# I-5: N. Ashland Interchange – Green Springs Project Aesthetics Advisory Committee (AAC)

## Meeting #4 Summary

February 25, 2009  
11:30 a.m. – 1:30 p.m.

**CONCEPT A**

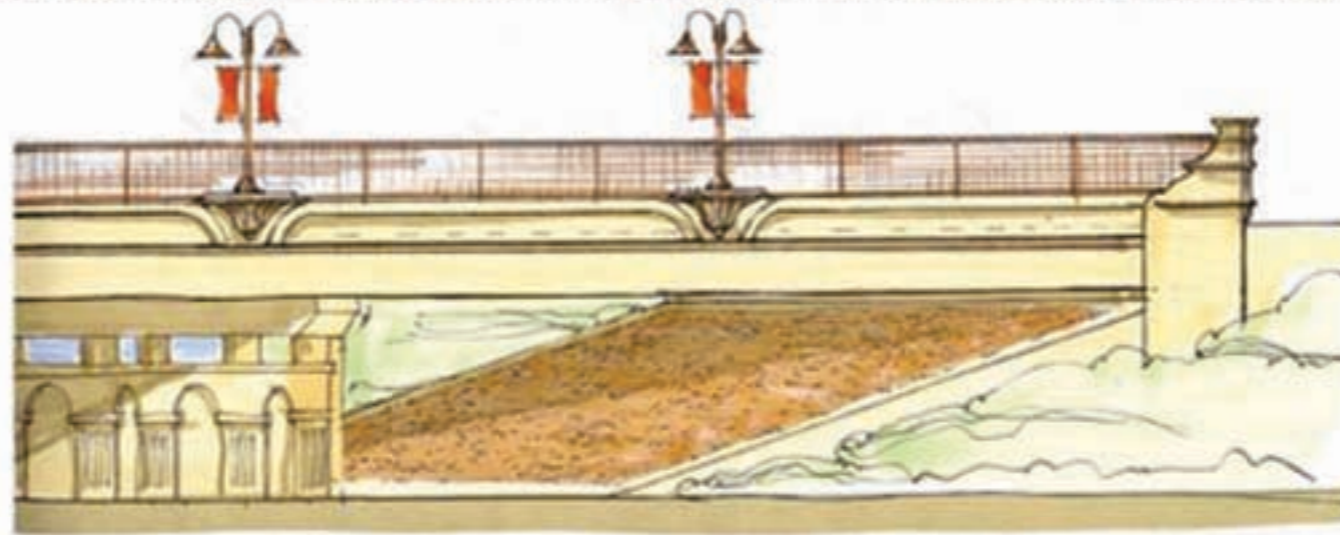
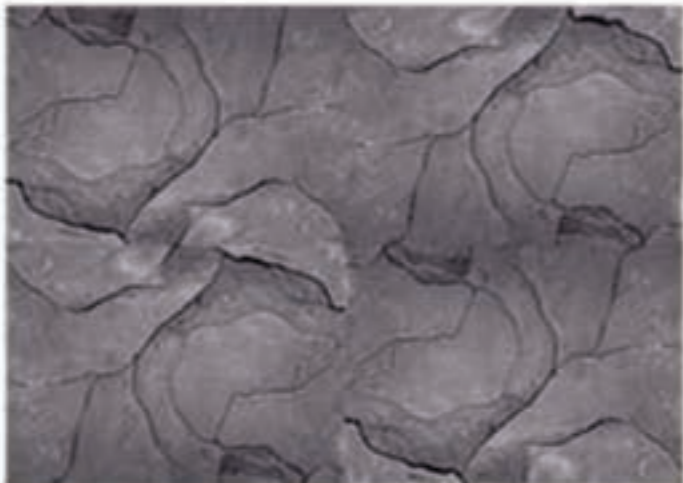
Concept A showed the bridge span with walls to give the impression of arches and columns, integrated color concrete, and a rusty reddish brown color for protective fencing. The end bents of the parapet and fencing featured a design motif derived from the Mark Anthony Hotel (or what some AAC members called the Lithia Hotel). Options for the abutments were shown in cobble and slate form liner. The design also featured pedestrian lighting with banners and poles inset in corbels on the outside of the bridge deck.

Alex asked what the group liked about the designs. Many immediately liked the Mark Anthony/Lithia Hotel-inspired design motif that was featured in the pedestrian fencing and end bents with Option A (*sketch on left*). Some thought that design would also work well on the corbels for the light poles on the outside of the bridge deck or possibly on the bridge piers as well. Others thought the corbels made the designs look too busy. Opinions differed on whether the bridge deck should have clean lines devoid of additional detailing or whether there should be design detail wherever a light pole was located. Everyone agreed that a balance should be maintained between any designs on both the bridge deck and the fencing. “Keep it subtle” was stated.

The committee discussed the pedestrian fencing options. Most liked the design depicted on Option A. The inset detail that included a stylized version of the Mark Anthony/Lithia Hotel motif in the railing was also popular. A suggestion was made to show examples of the railing with and without the motif, including one motif in the center of the bridge fencing and another that shows a motif in the fencing wherever there is a light pole.

**EXTERIOR VIEW OF CONCEPT B**

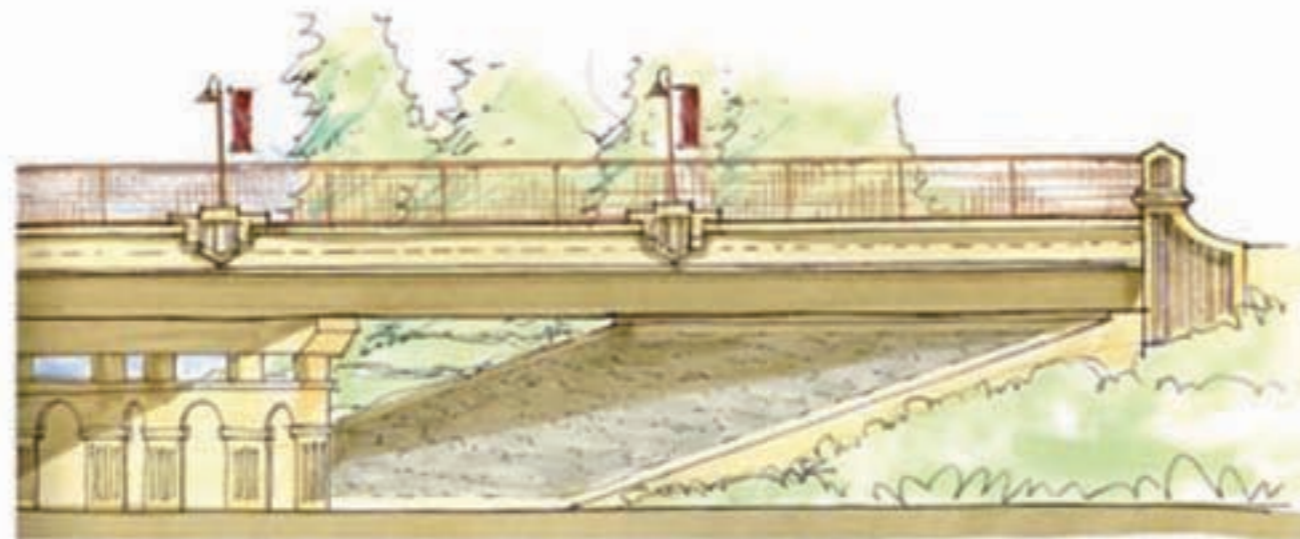
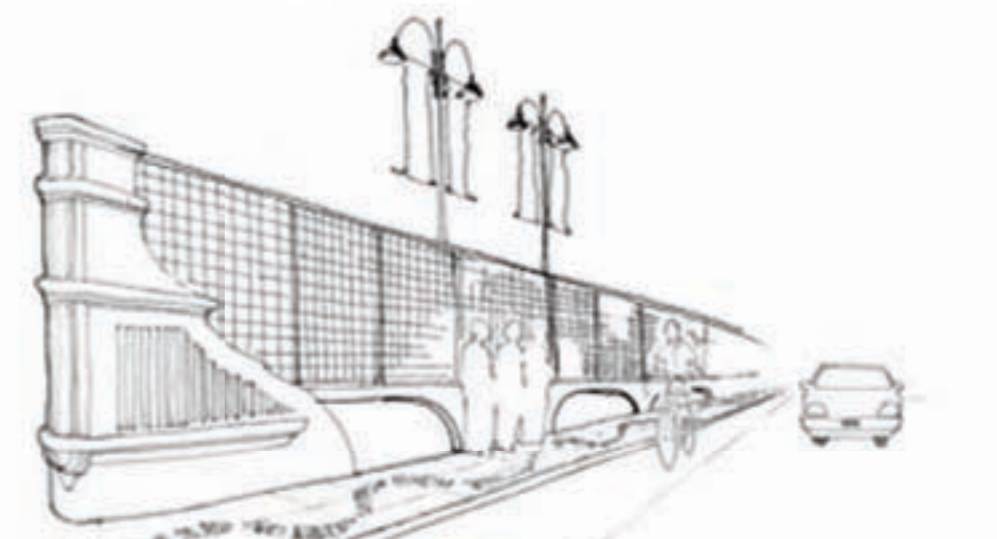
Concept B was similar to Concept A with the arched column design. The key differences were that the end bents featured a vertical treatment instead of the sloping Anthony Hotel design and the corbels were flared.

Most members preferred the end bend that tapered down vs. the vertical end bent. The tapering would match the tapered abutments and retaining walls that were also favored by the committee.

**CONCEPT C**

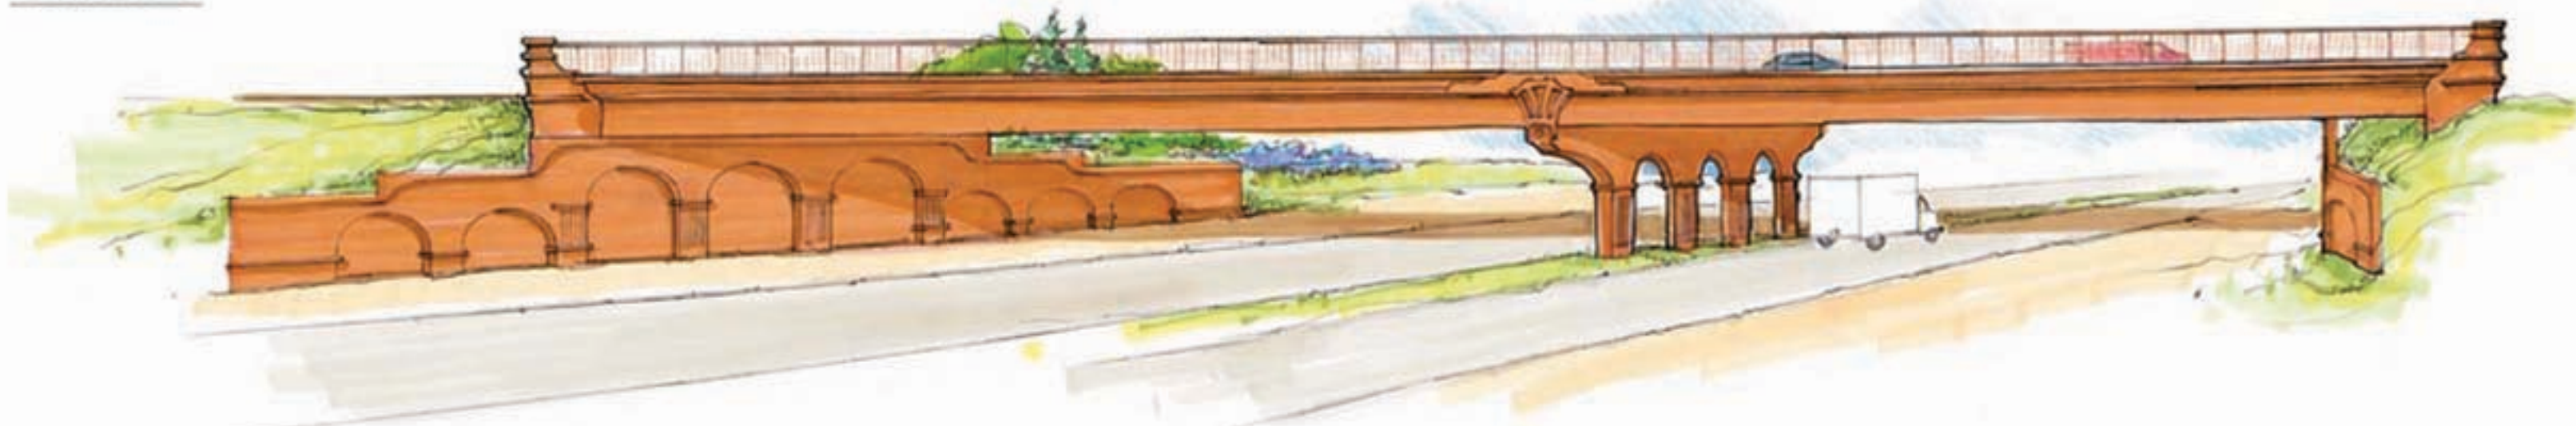
Concept C showed a design for Exit 19 reminiscent of Exit 14, with arched column arcade relief in the abutment and arched center piers. Retaining wall options were also shown for cobble and slate form liner.

For Exit 19 (Concept C), the group generally agreed that the arched design didn’t work; they again favor a simpler Art Deco design with cleaner lines for this location. A suggestion was made to taper the abutment in a natural curve instead of stair-stepping it down from the bridge deck to the roadway. The use of natural slate form liner in this location was favored also.
